FINAL ENVIRONMENTAL IMPACT STATEMENT

XCEL ENERGY PRAIRIE ISLAND NUCLEAR GENERATING PLANT

EXTENDED POWER UPRATE PROJECT

REQUEST FOR ADDITIONAL DRY CASK STORAGE

Figure 3.3 Transnuclear TN-40 Dry Storage Cask

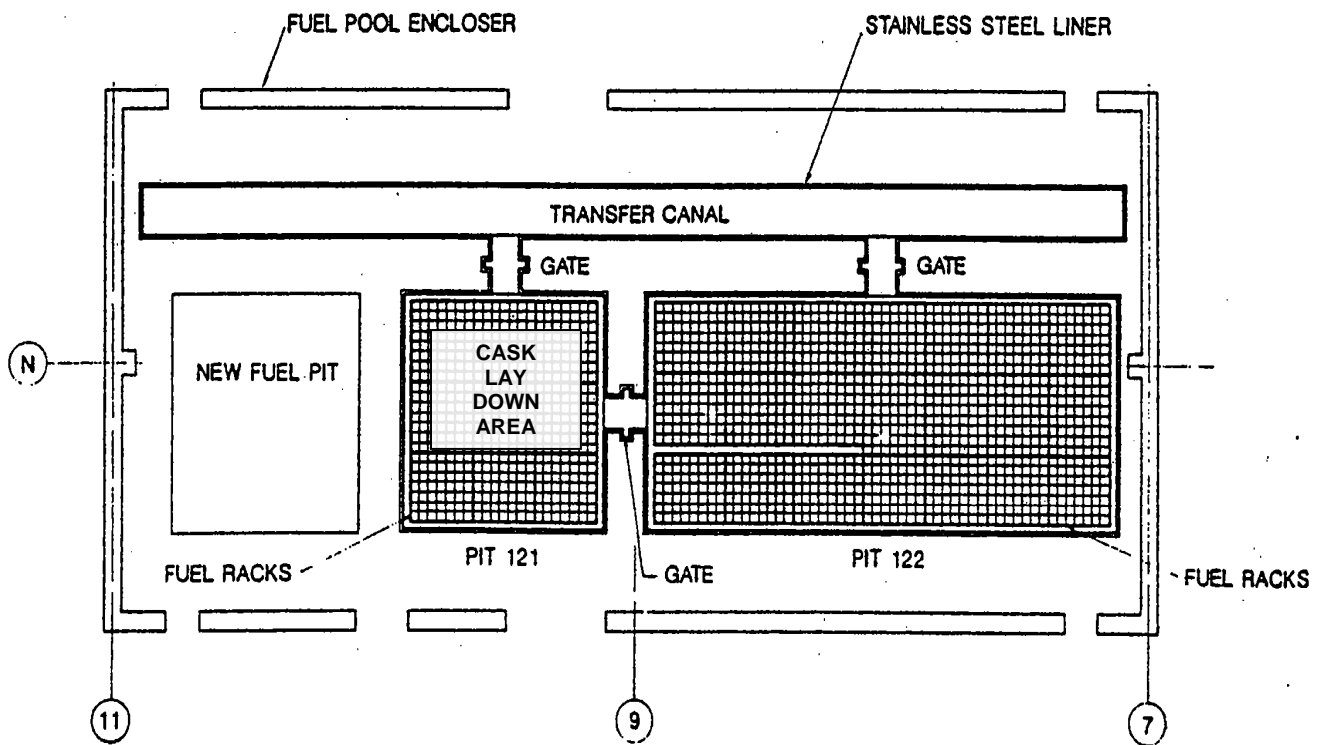
14-33 | **Figure 3.3 Transnuclear TN-40 Dry Storage Cask**

The picture is slightly distorted and doesn’t indicate its true dimensions. It should be “stretched out” provide a better visual perspective of the cask diameter to its height. See figure 3-13 of the Certificates of Need for an example.

Table 5-3 has been edited to correct the SAR skyshine dose assumptions. Figure 3.3 has been edited to correct the perspective of the TN-40 cask.
